**FINAL DRAINAGE REPORT
FOR
FOUNTAIN VALLEY SALVATION ARMY
208 CUNNINGHAM DRIVE
COLORADO SPRINGS, CO 80911**

R&R Engineers-Surveyors

June 2, 2022
Revised: December 22, 2023

PCD Filing No.: **COM-2117** ← **CDR242**

Project: **208 Cunningham Drive**

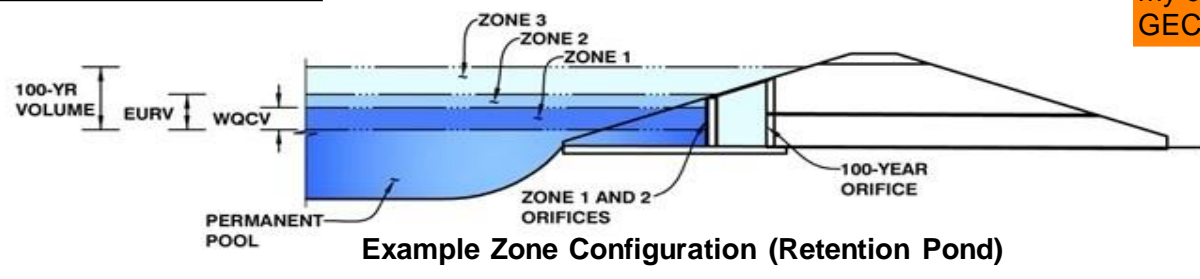
Input the ID for the PLD once one is created, per my comment on the GEC Plan.
